AGREEMENT

Re: Site Plan Review – Proposed Dunkin' w/ Drive-Thru; 2203-2227 Paterson-Hamburg Turnpike, Wayne; Block 3510, Lots 159, 163 & 164 (Passaic County File Number SP-24-049)

The above referenced site plan prepared by Mathew J. Bersch, P.E. (N.J. Lic. No. 54522) and dated October 9th, 2024, revised as of March 23rd, 2026, was reviewed by the Passaic County Development Review Committee on May 6th, 2026 pursuant to the provisions of the Passaic County Site Plan Resolution.

This site plan application has been granted **conditional approval** pending receipt in an acceptable form of the following:

SITE PLAN
PROJECT: HAMBURG TURNPIKE
SHEET NO.: 6
DATE: 10/15/2024
DRAWN BY: J. SMITH
CHECKED BY: M. JONES
DESIGNED BY: R. P. FREUD
APPROVED BY: M. JONES
MATTHEW J. FREUD, P.E.
REGISTERED PROFESSIONAL ENGINEER
STATE OF MARYLAND, LICENSE NO. 12345

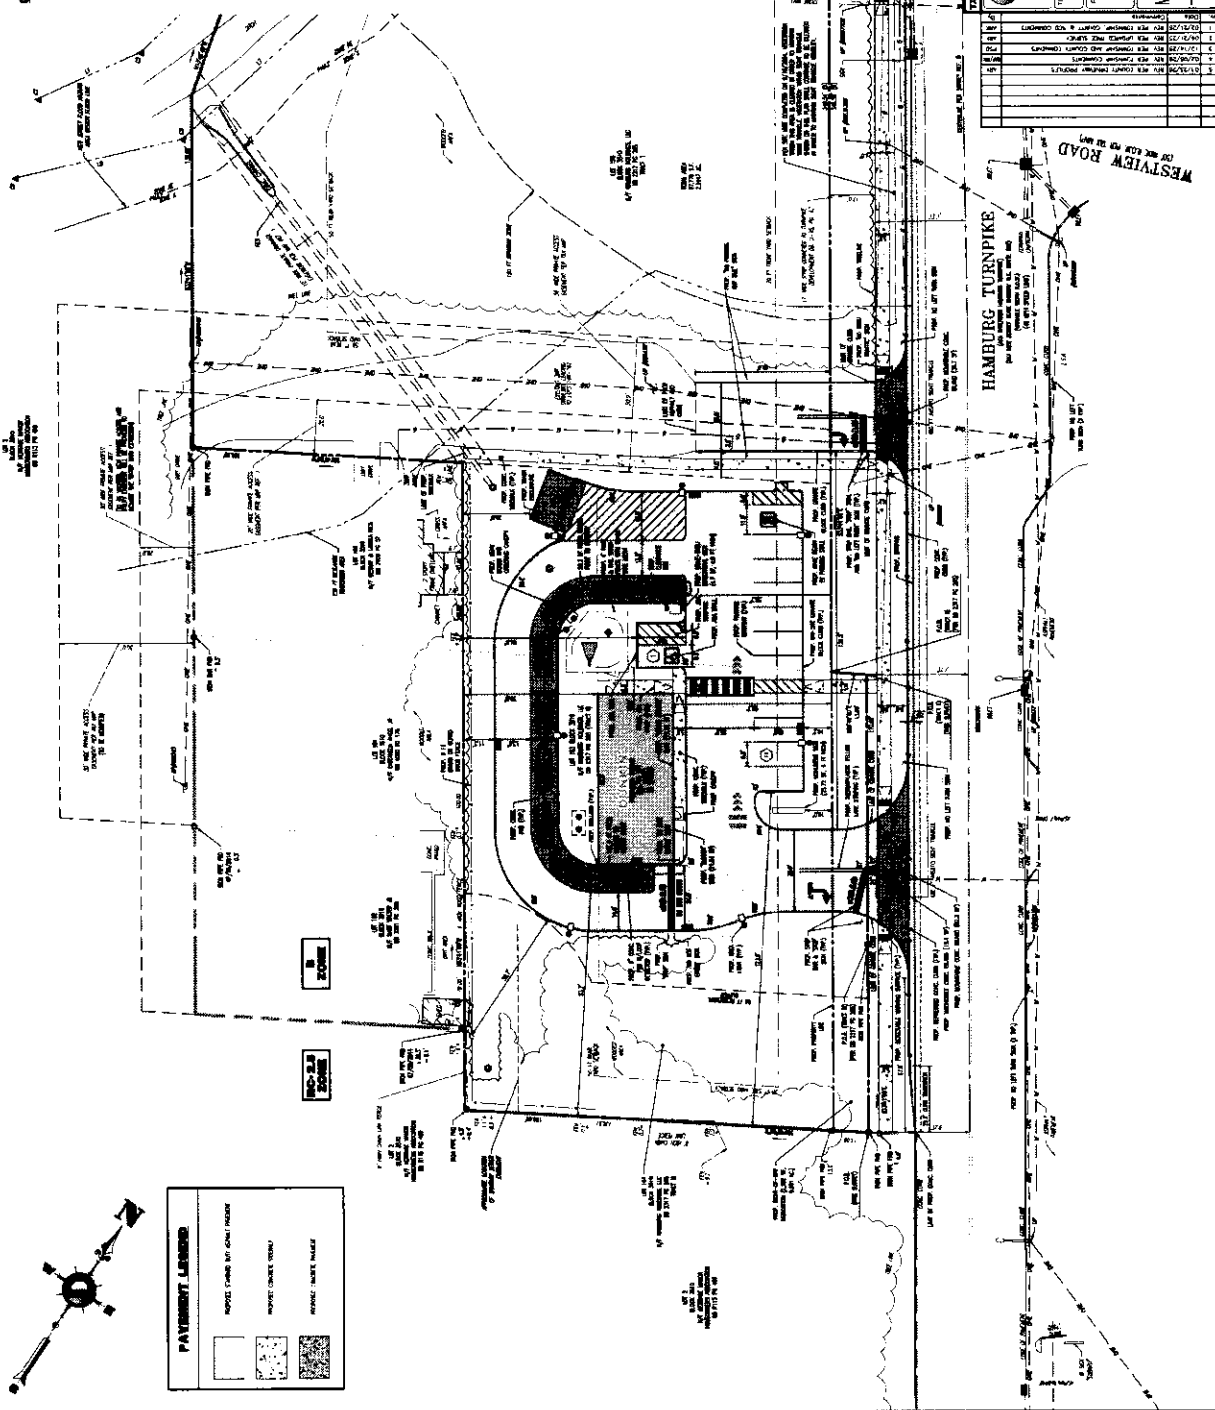
WHEREAS, the Site Plan Approval, specifically requires the Applicant to enter into an agreement to dedicate a strip of its property that extends 17 feet from the roadway centerline towards the Project, at a later date when requested by the Passaic County Engineer ("County Engineer") or the County DRC, at no cost to the County; and

2. The Parties understand and acknowledge that the Master Plan currently provides for a right-of-way of 100 feet and is depicted on the Applicant's Site Plan.

3. The Parties further understand and acknowledged that the Applicant's Site Plan provides a variable width right-of-way in partial compliance with the Master Plan right-of-way, leaving the Applicant with providing for an additional future right-of-way dedication equal to 17 feet.

1. The applicant name and address must be listed on the cover sheet. *Previously completed.*
2. The applicant shall show the remainder of the Master Plan right-of-way on the plans and enter into an "if and when" agreement with the County to acquire the up to the full width of the Master Plan right-of-way. *The applicant shall confirm if there is a previous dedication. If so, the applicant shall provide a copy of the existing dedication that is noted on the plans. There is an existing easement for right-of-way widening along the site frontage. The applicant shall enter into an "if and when" agreement that would allow the County to require a future right-of-way dedication up to the Master Plan right-of-way line of Paterson-Hamburg Turnpike. An agreement template is attached for the applicant's review and signature.*
